DART SERVICE INSTRUCTION

TO AMEND IIN-D412-704 REV. C OR EARLIER
AND ICA-D412-704 REV. 4 OR EARLIER
REF CANADIAN STC SH93-34
REF FAA STC SR00957NY
REF EASA STC EASA.IM.R.00696

PURPOSE

Figure 5 - Detail L or Figure 25-4 - Detail L

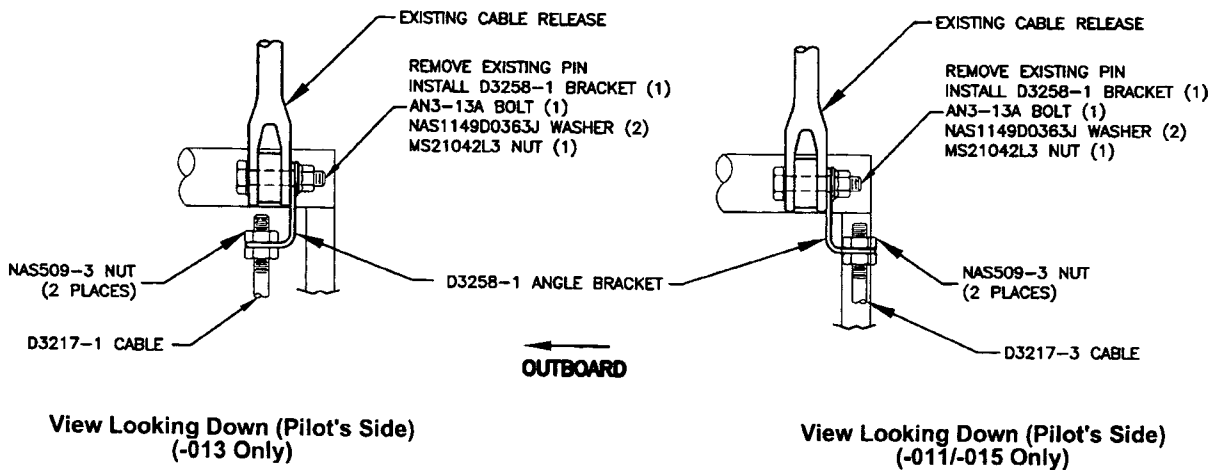
The purpose of this Dart Service Instruction is to correct part number error in Installations Instruction IIN-D412-704 Rev. C or earlier and Instructions for Continued Airworthiness ICA-D412-704 Rev. 4 or earlier. The AN3-13A bolt should be replaced with an AN3-10A bolt in Figure 5 - Detail L in IIN-D412-704 and Figure 25-4 Detail L in ICA-D412-704. See sheet 2.

FIGURES CORRECTION

Revise Detail L Figure 5 of IIN-D412-704 and Detail L Figure 25-4 of ICA-D412-704 as follows:

NOW

WAS
